## CITY of NOVI CITY COUNCIL

Agenda Item 6  
August 24, 2015

**SUBJECT:** Consideration of a request from Michael and Rachael O'Sullivan for a variance from Section 11-216(e)(8) and Section 11-256(f) of the Design and Construction Standards, which allows a maximum driveway slope of 10% and a maximum sidewalk cross slope of 2%, to allow the applicant to maintain the slopes as-constructed for the construction of a home at 21379 Equestrian Trail (parcel 22-32-401-074).

Sec. 11-216. - Design considerations.

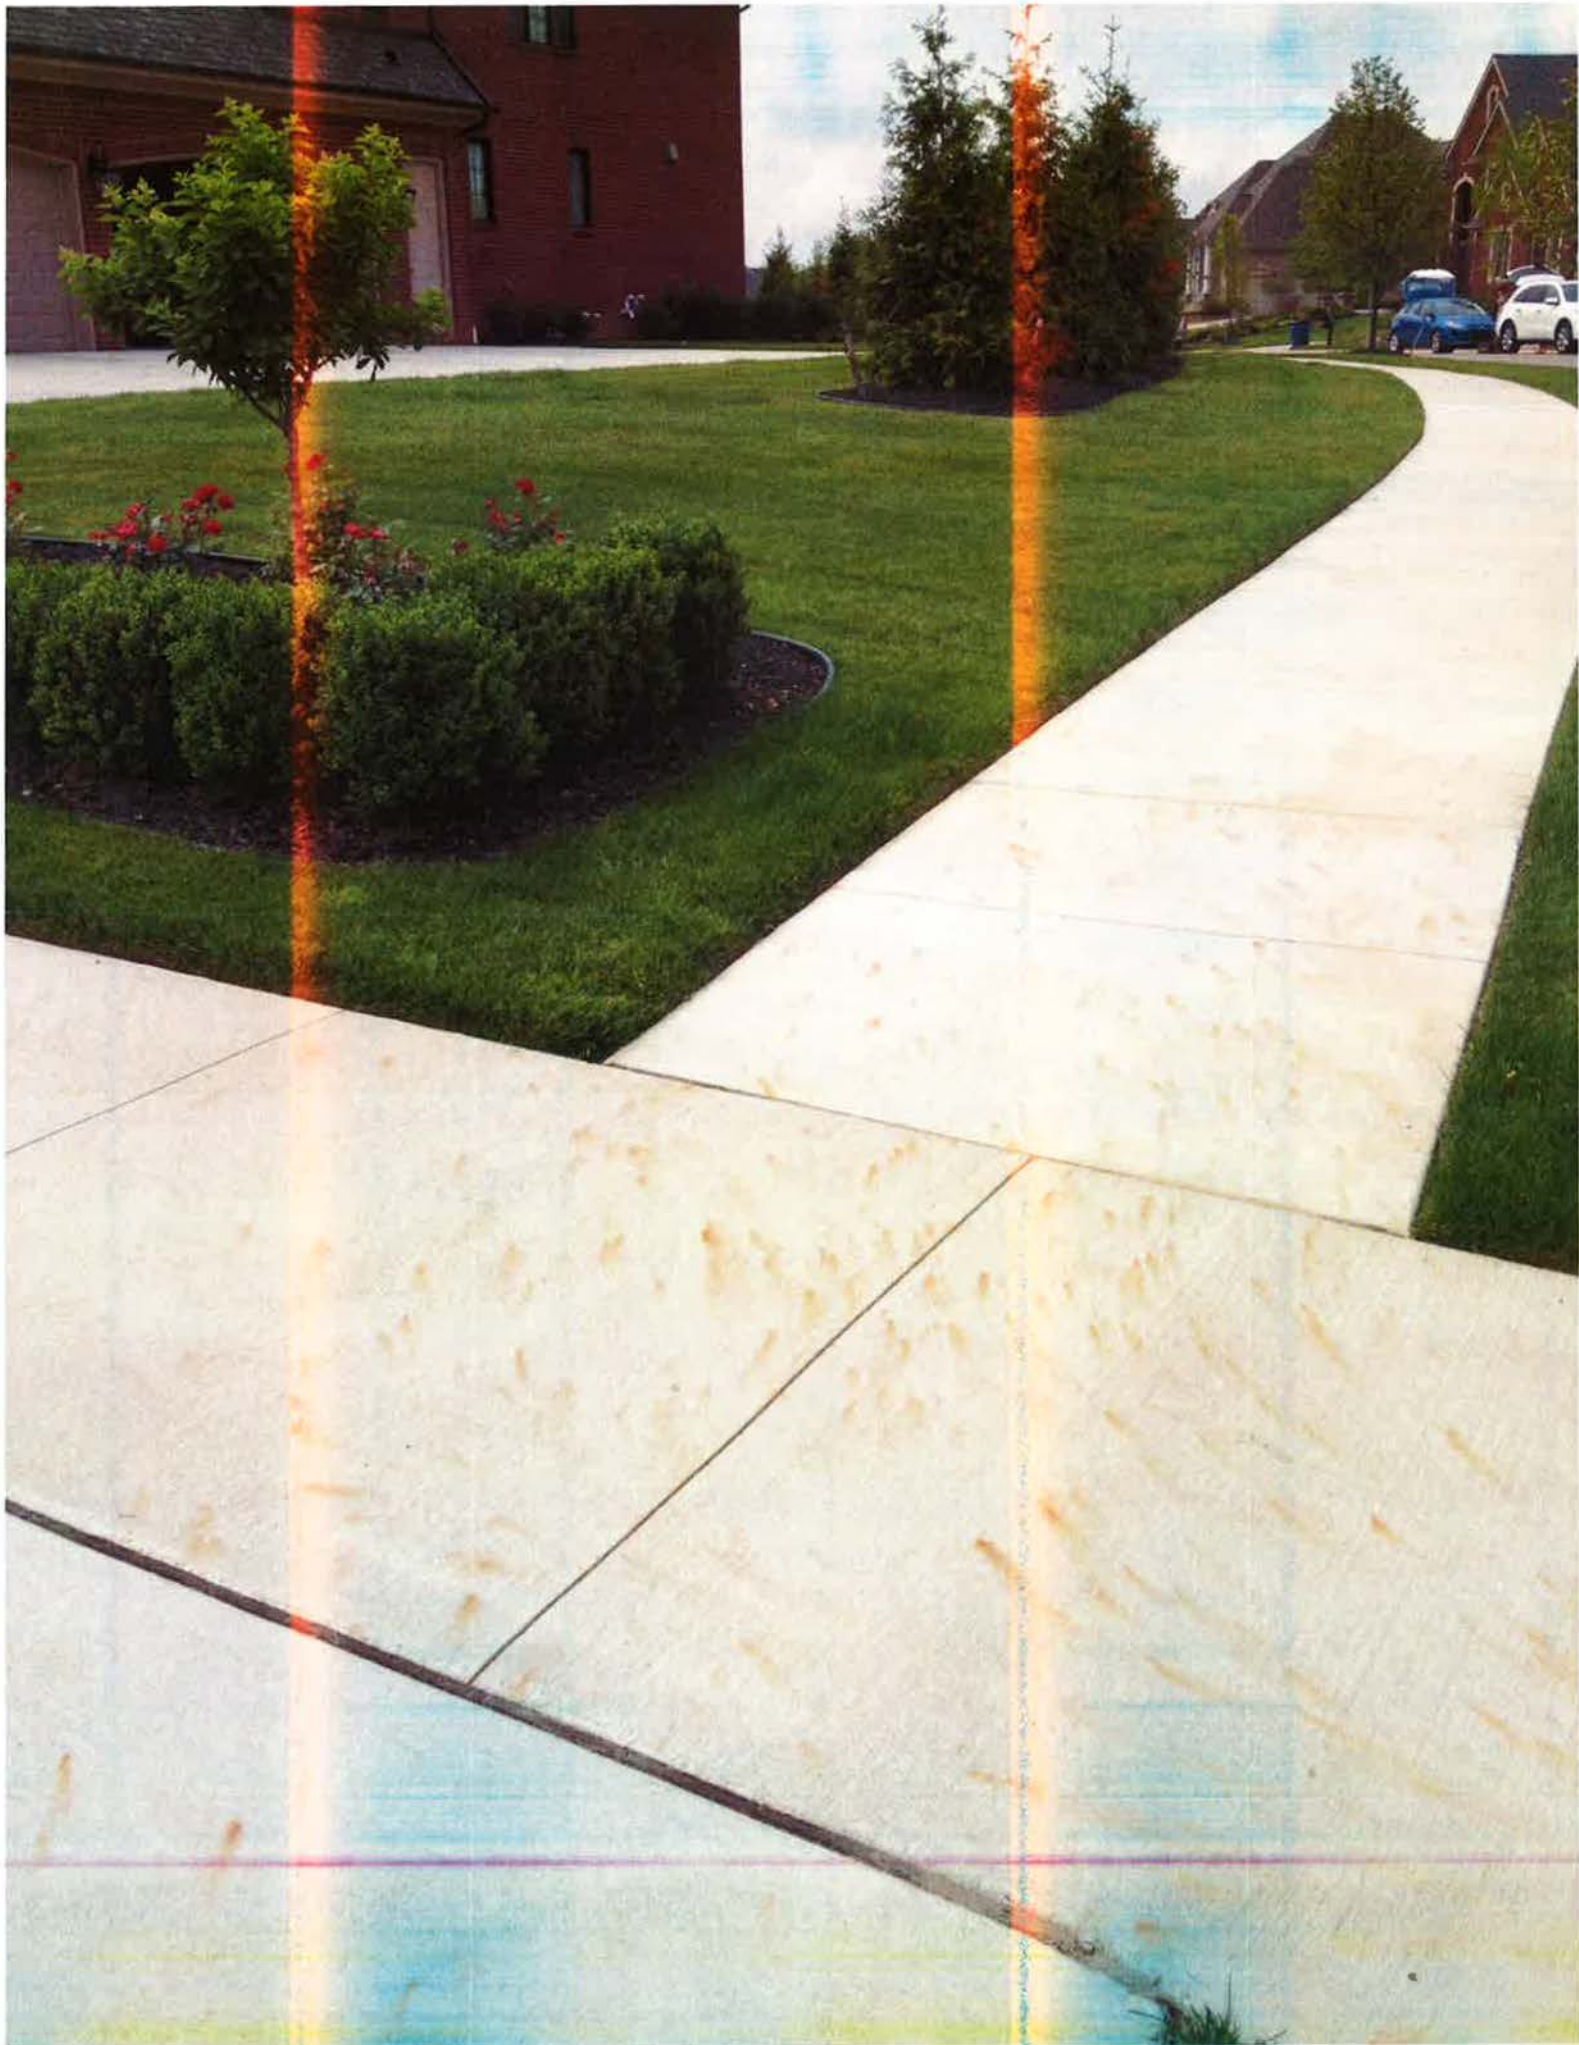
The ordinance sets a maximum running slope for a driveway at 10%, whereas the as-constructed slope on the easterly driveway is 11-14%. The applicant said that they changed the slope in the field because of a manhole that was too low. However, the manhole could have been adjusted to better accommodate the slope shown on the approved plan. Since the driveway is located on private property and the property owner is willing to accept the condition, staff can support this part of the variance request.

The Engineering Design standards set the maximum cross-slope of a sidewalk at 2%, which is consistent with the Federal Americans with Disabilities Act (ADA) Standard, attached. The sidewalk cross slopes as constructed in the field exceed the 2% maximum in more than half the locations measured. Since Equestrian Trail is a private street, it would be the responsibility of the condominium owners to ultimately make the sidewalk cross slope compliant with ADA Standards, not the City. However, the review standard for the variance in Section 11-10 of the ordinance requires that "the granting of the variance will not be detrimental to public health, safety, or welfare..." The federal requirement for the sidewalk cross-slope is primarily intended to protect wheelchair users from becoming unstable. In this situation, the constructed cross slopes of 3-4% could pose a risk to sidewalk users in wheelchairs. The only remedy for the situation is to remove and replace several sections of sidewalk, which would be expensive for the applicant. However, the constructed sidewalk substantially deviates from the standard and poses safety concerns to a segment of the population. For these reasons, staff cannot recommend approval of this part of the variance request.

- Multiple areas of sidewalk + drive are > max allowed slopes (2% for walks; 10% for drives)

- Reference the copy of the red lined plan at the City

Approval of the request from Michael and Rachael O’Sullivan for a variance from Section 11-216(e)(8), which allows a maximum driveway slope of 10% to allow the applicant to maintain the driveway slopes as-constructed for the construction of a home at 21379 Equestrian Trail (parcel 22-32-401-074).

Denial of the request from Michael and Rachael O’Sullivan for a variance Section 11-256(f) of the Design and Construction Standards, which allows a maximum sidewalk cross slope of 2% for the following reasons:
